Revision Number	Date	Drawn	Details of Issue / Revision
P01	19/05/23		Response to RFI
P01	29/04/22		Issued for Planning

**Project Details:**  
 Dalguise  
 Monkstown

**Drawing Title:**  
 Proposed GA Plans - Block D

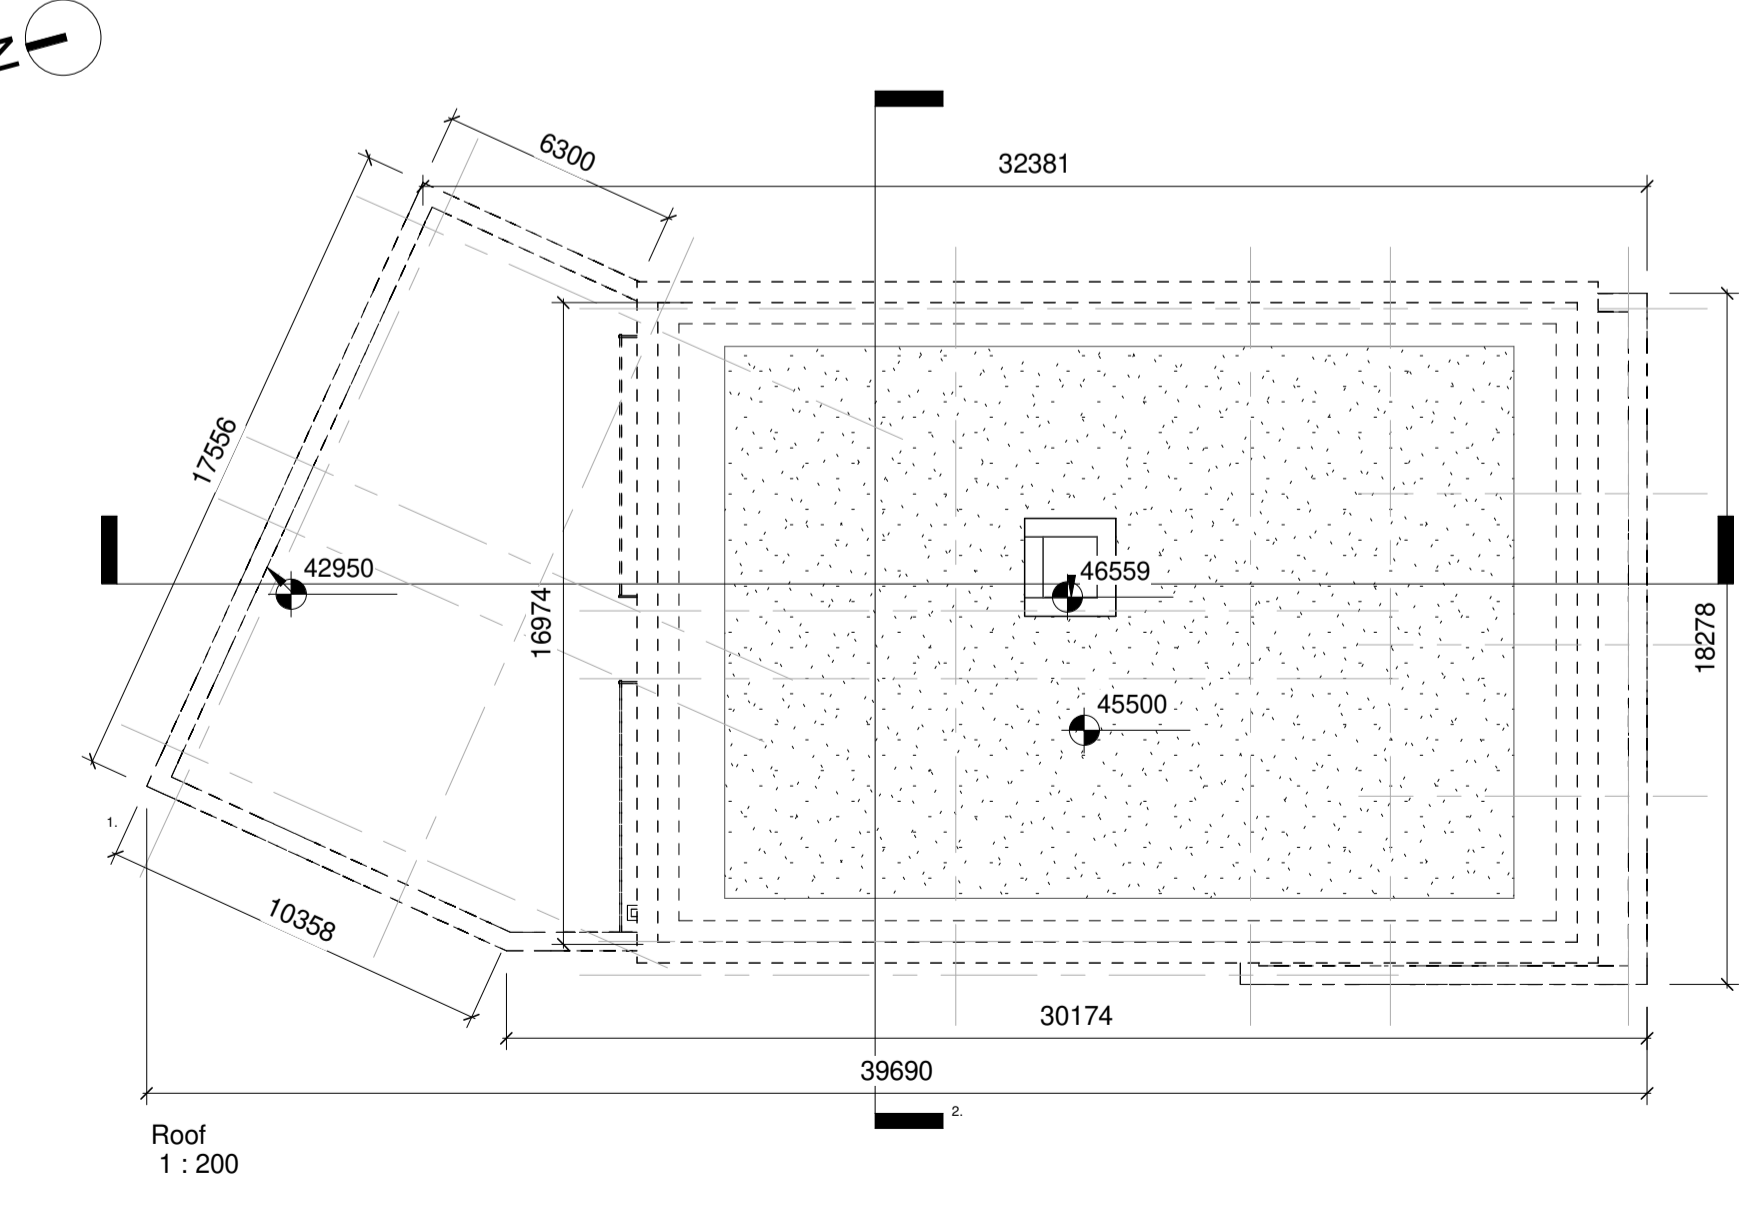
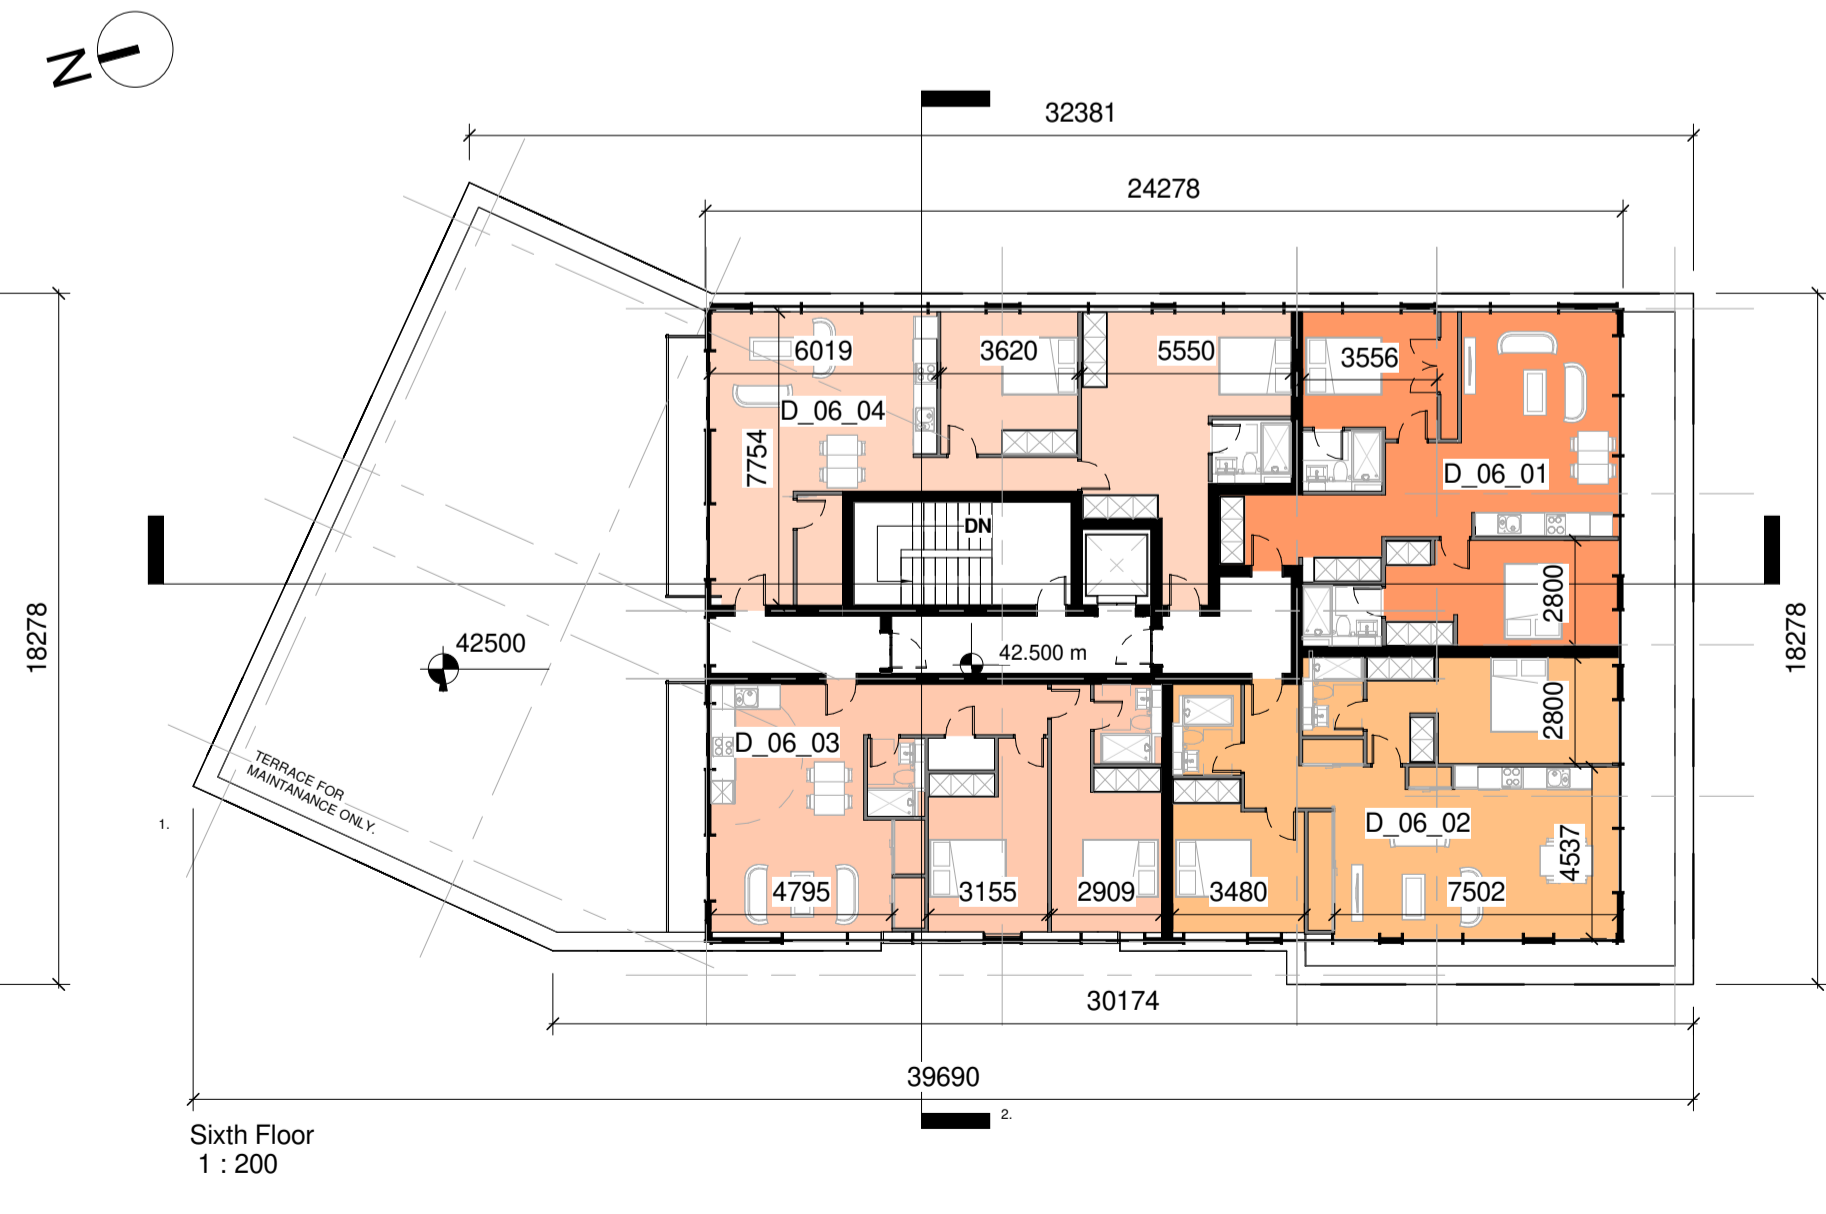
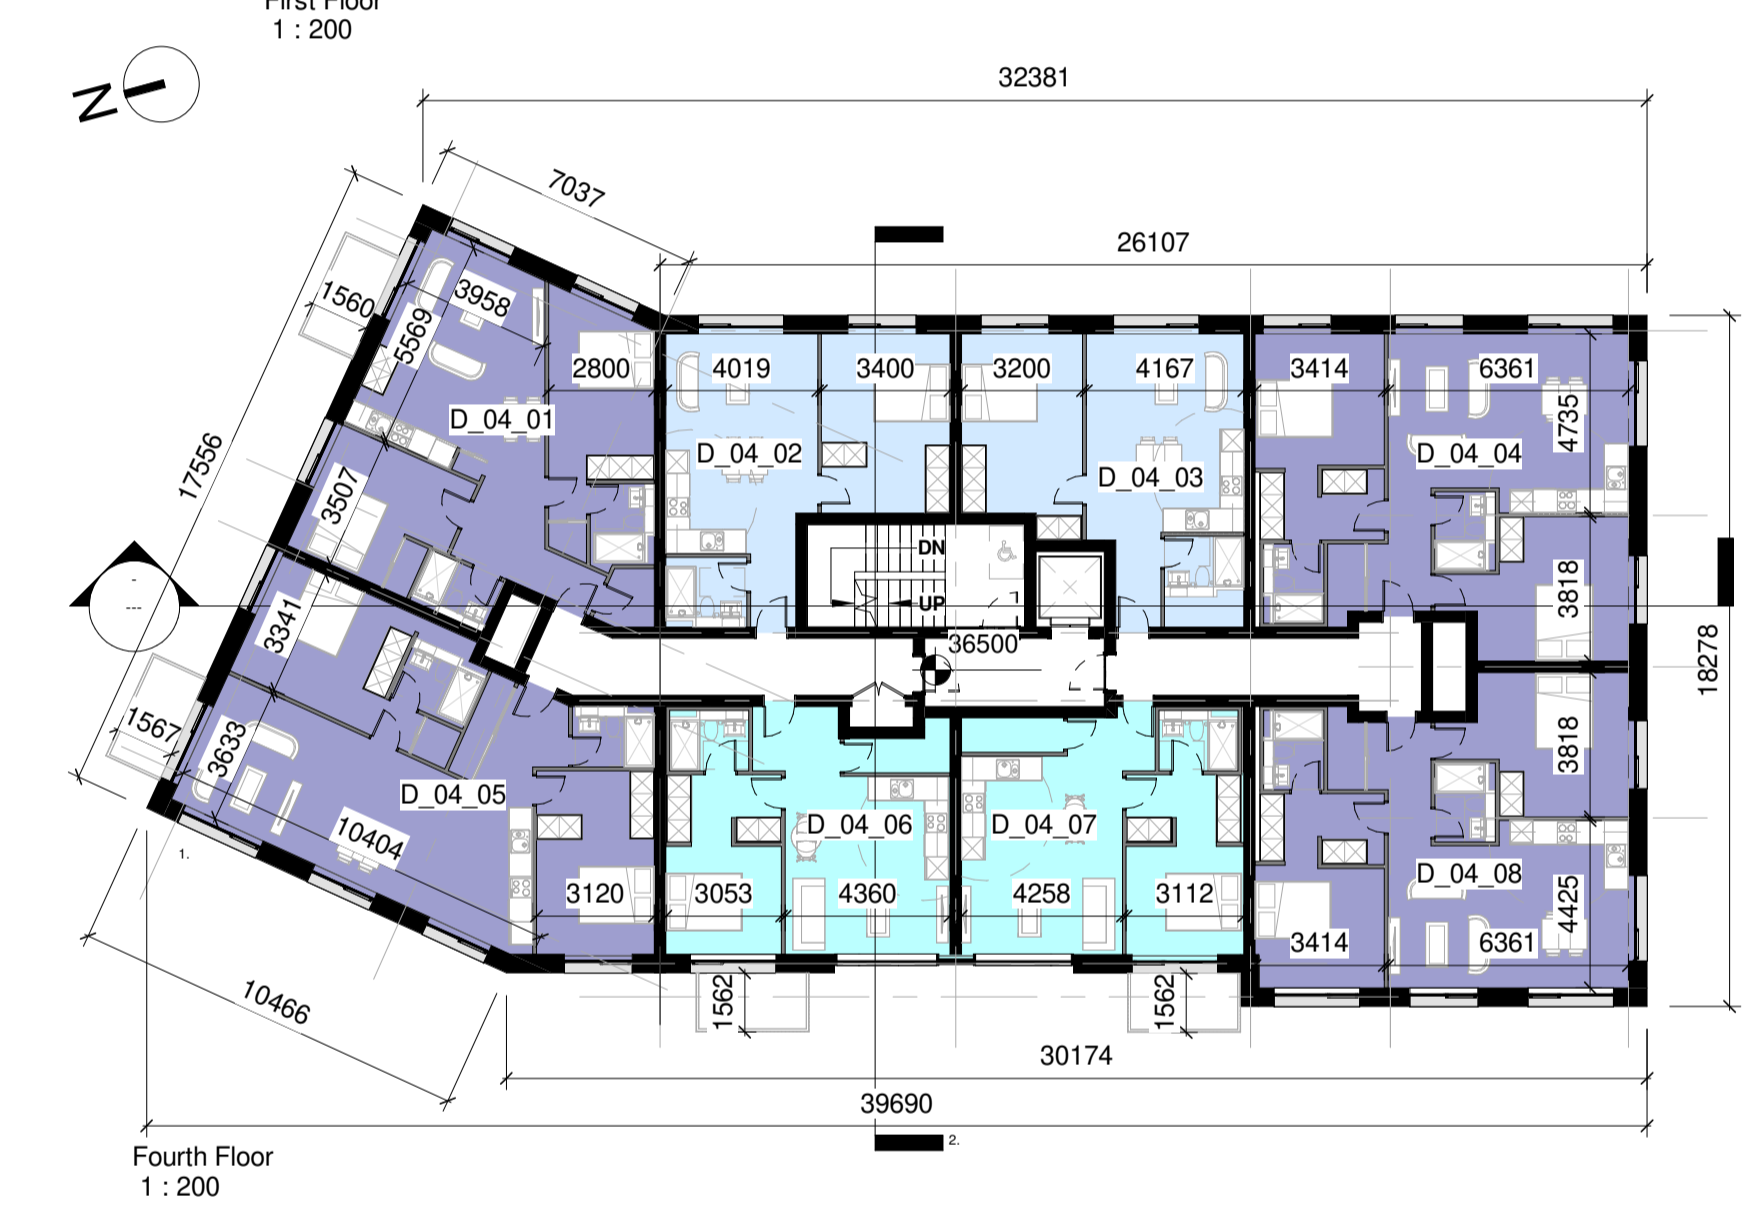
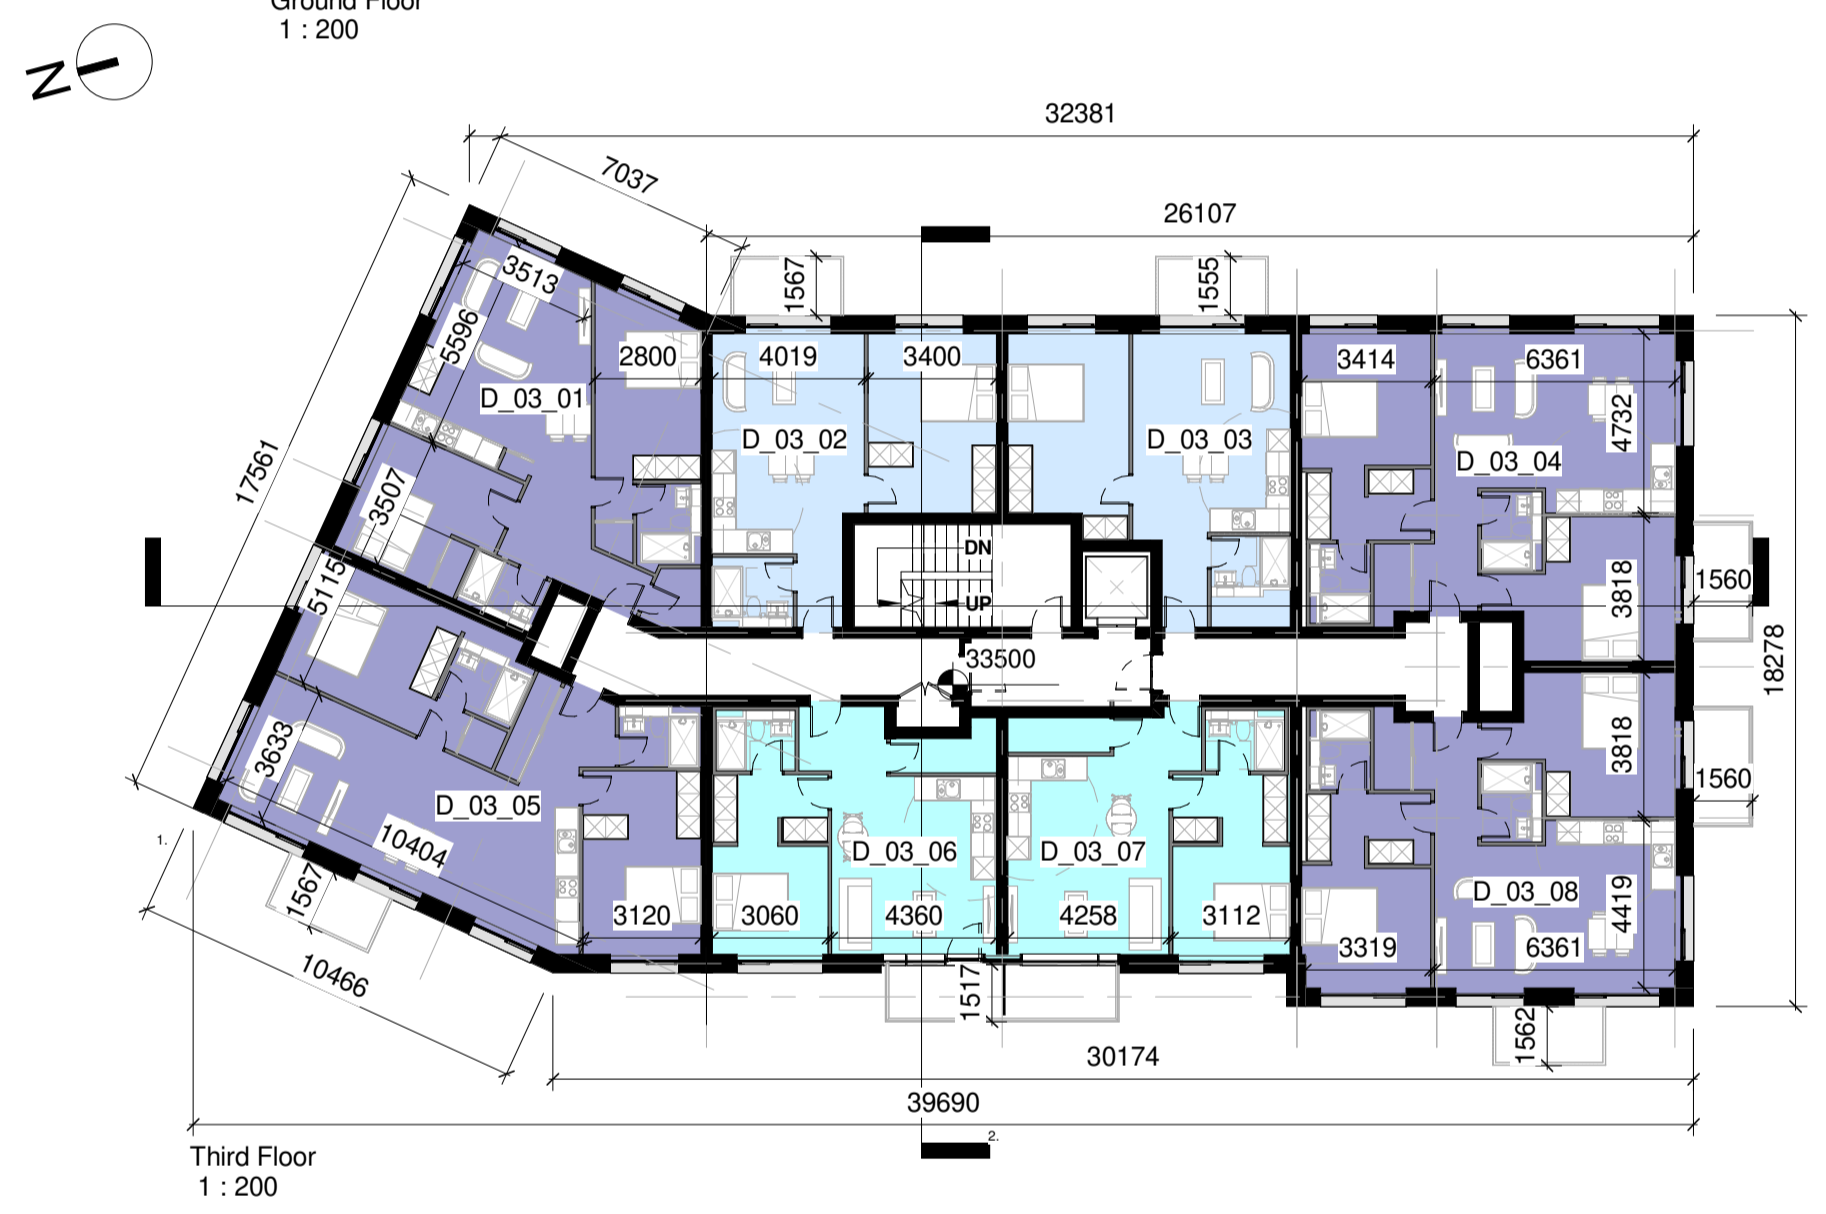
- D1. New Entrance added.
- D2. New 1 Bed Apartment added in lieu of Car Park Entrance Ramp.
- D3. New 3 Bed (5p) Apartment added in lieu of Car Park Entrance Ramp.
- D4. Minor alterations Roof Profile
- S6. Bicycle Entrance Widened with new separate access cycle route to Basement cycle stores
